COPPERSTRING EIS

Attachment F - Vegetation Clearing Works plans

Dajarra Road to Mount Isa

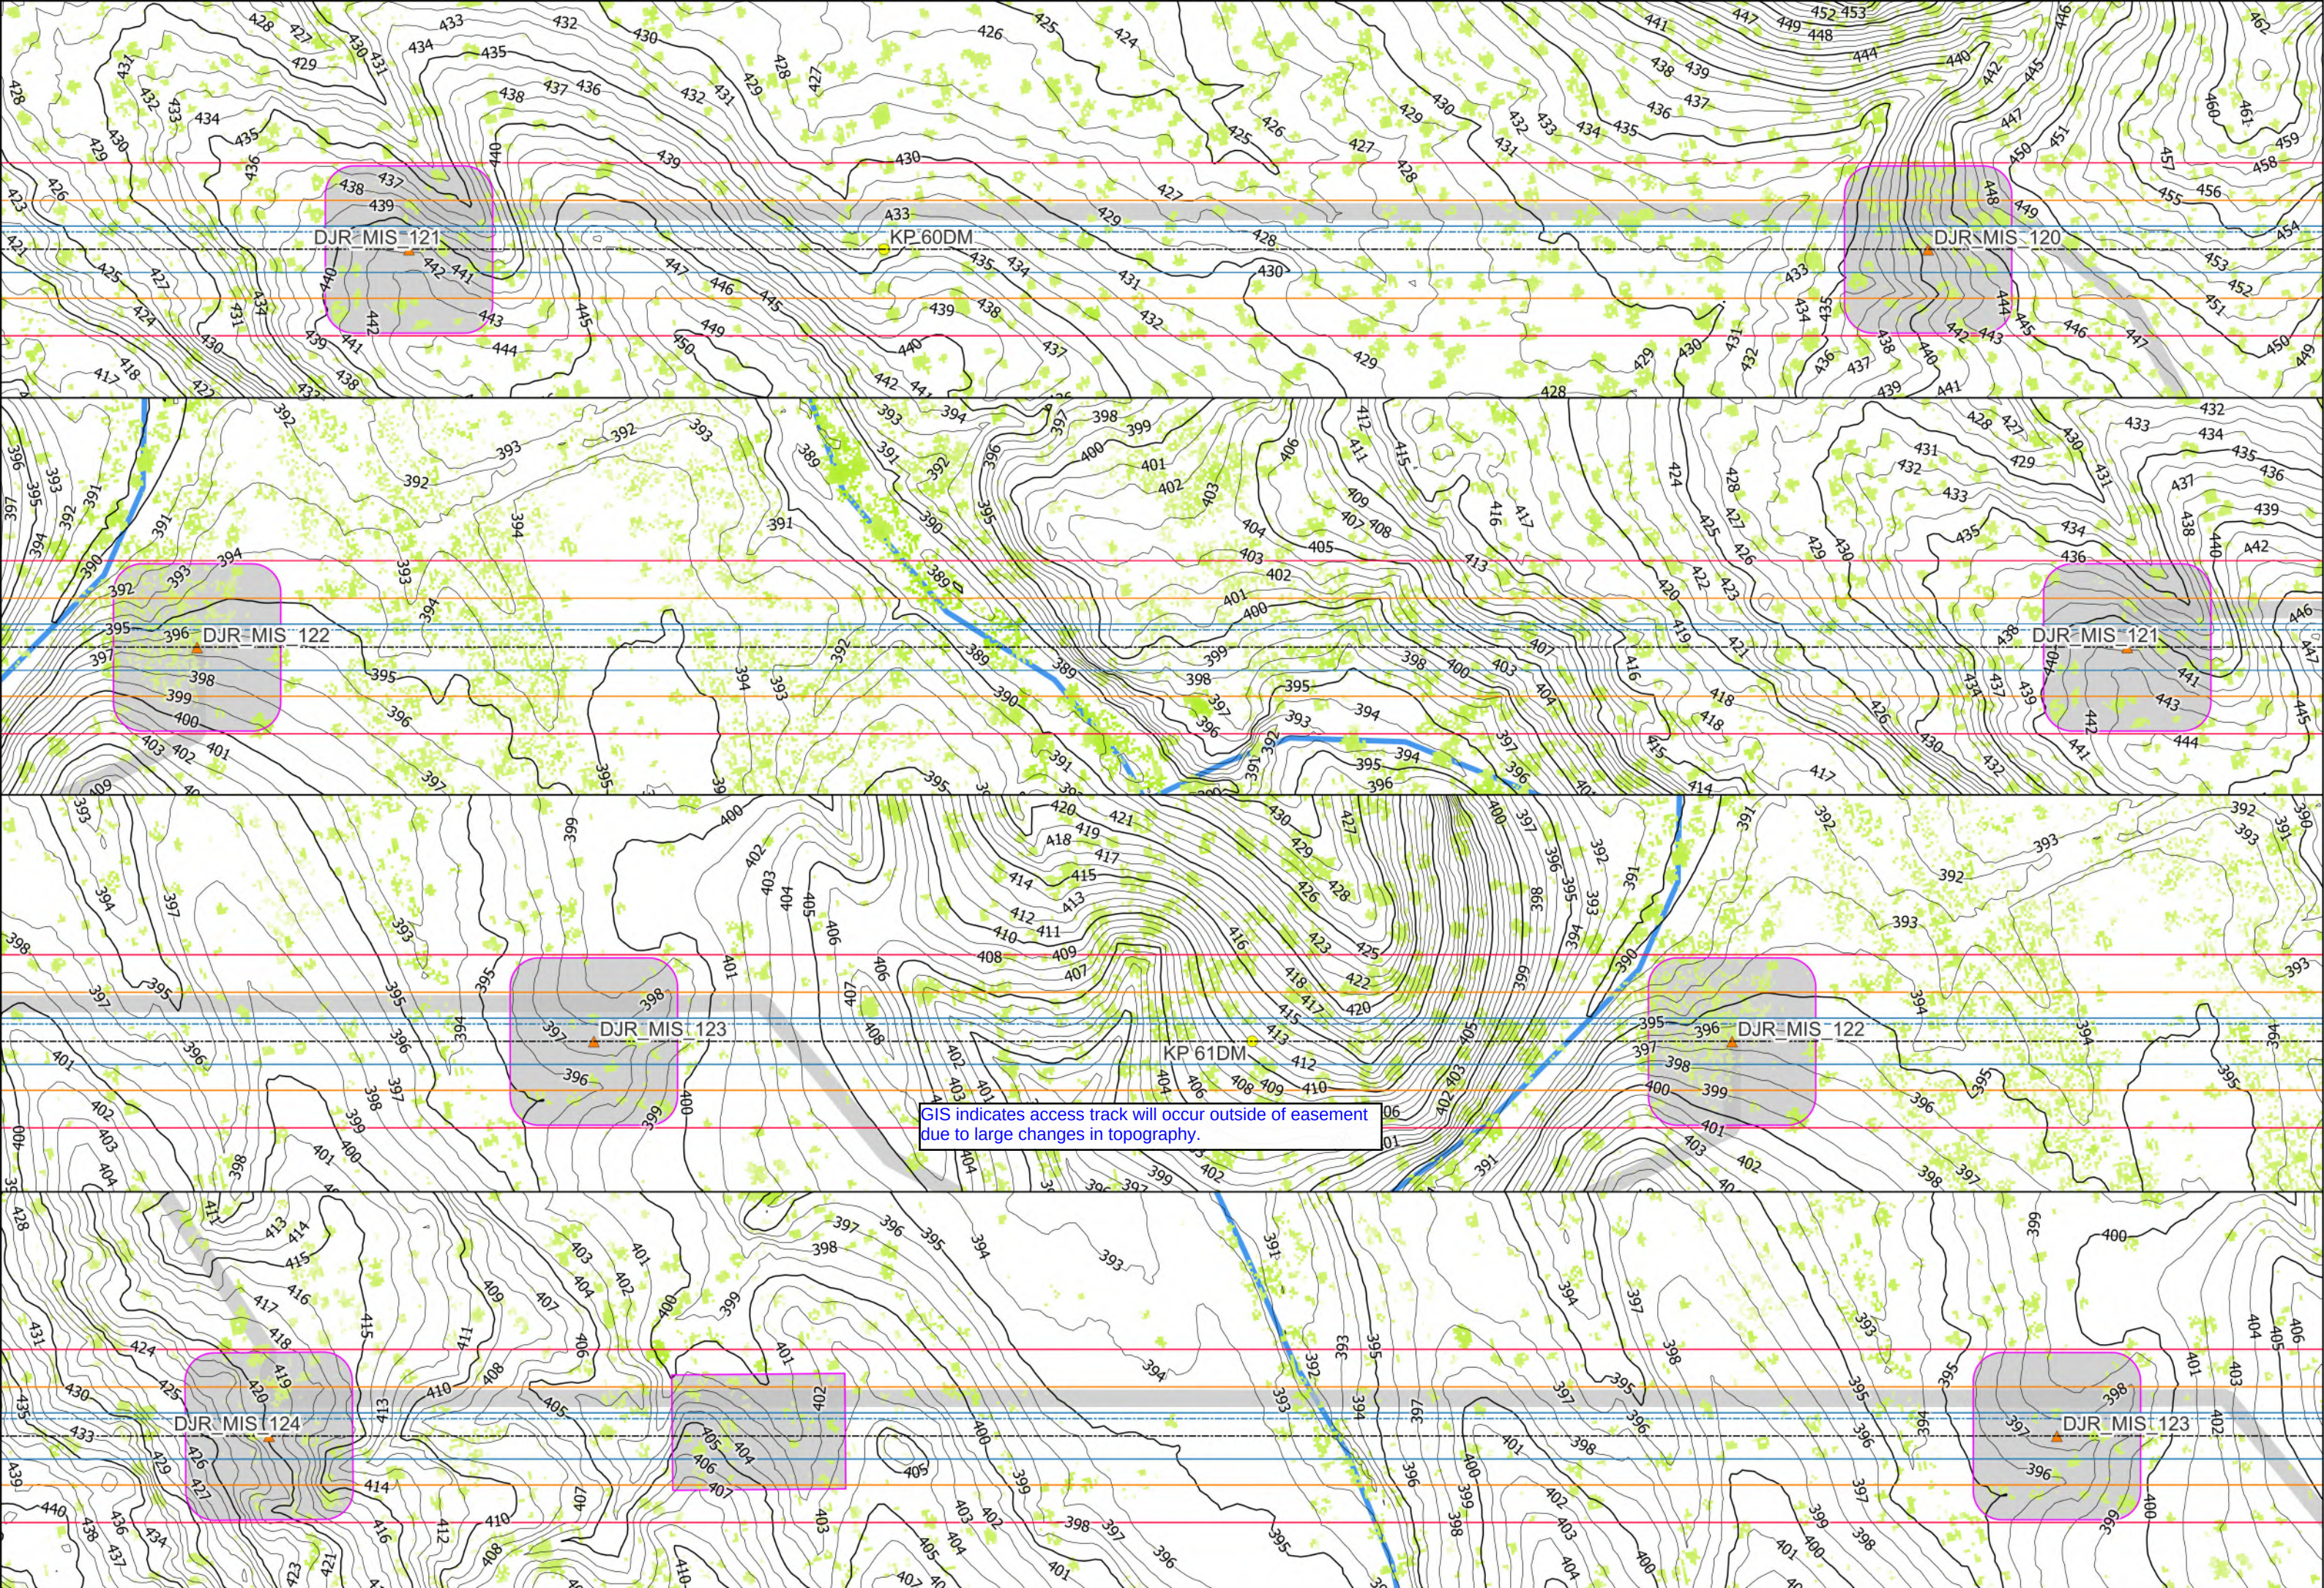
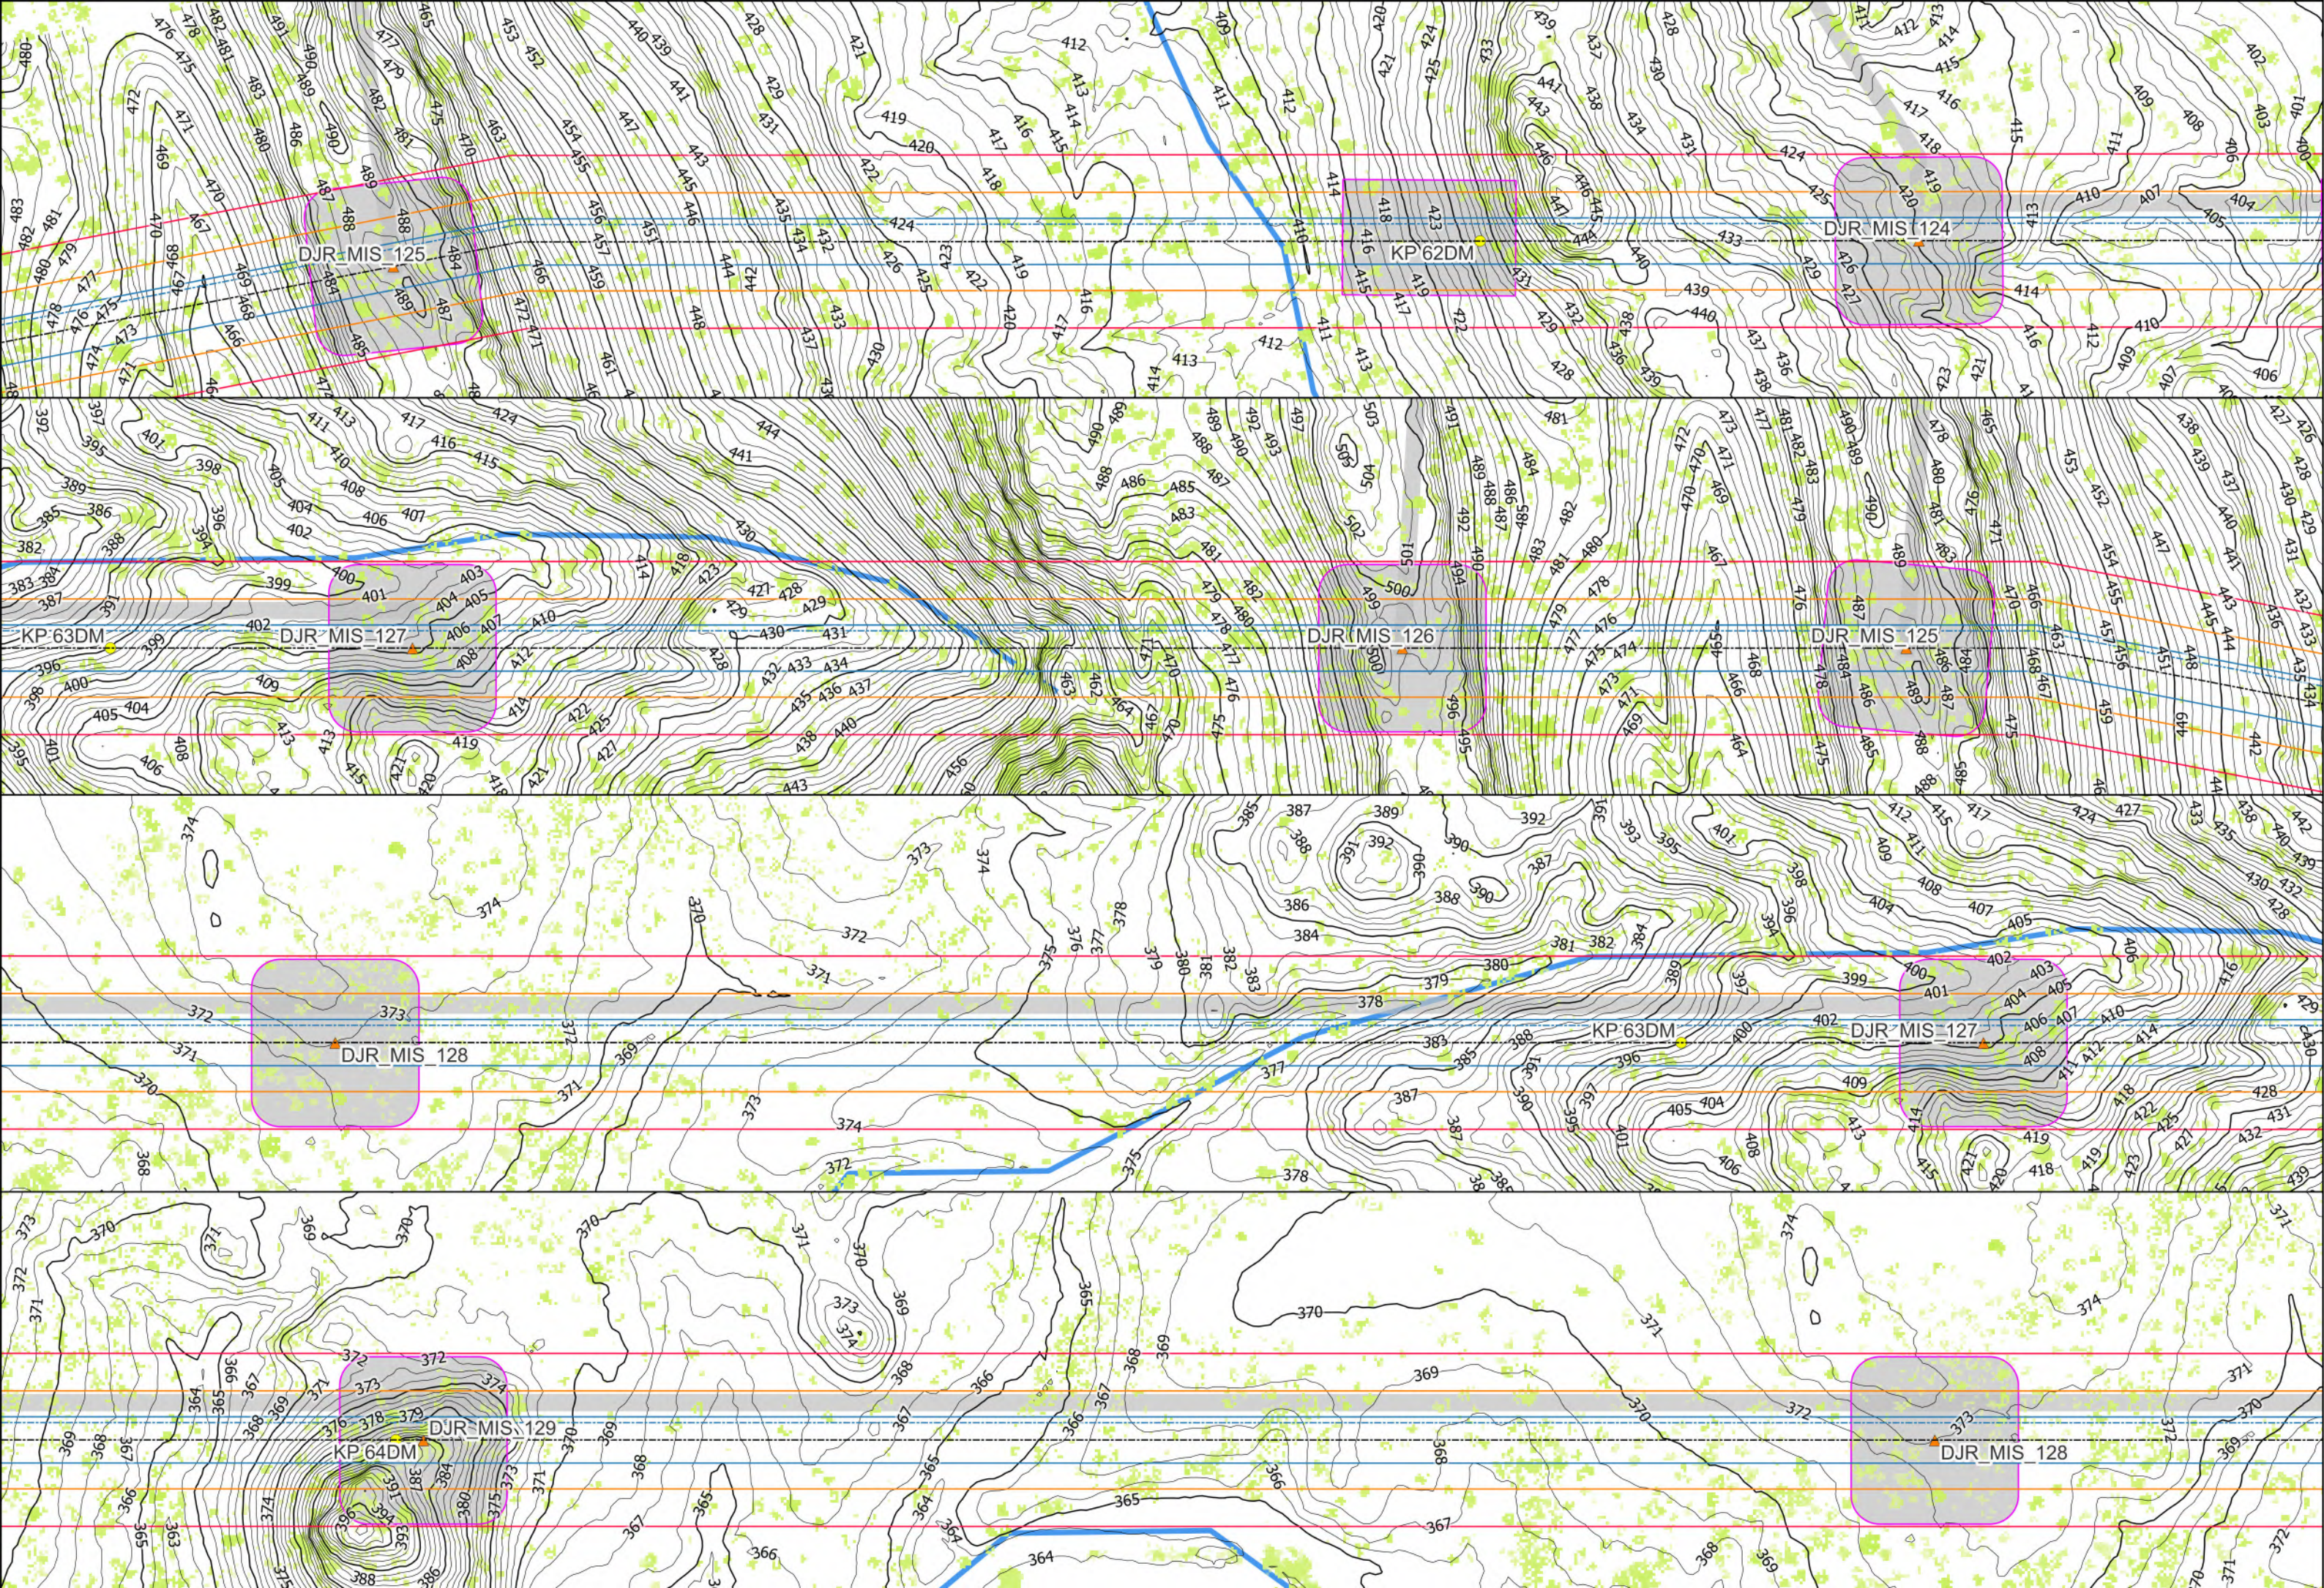
Tower assembly area to be reconfigured to not be within 15m of the high bank of waterway and to avoid clearing near or within the bed and banks for the waterway
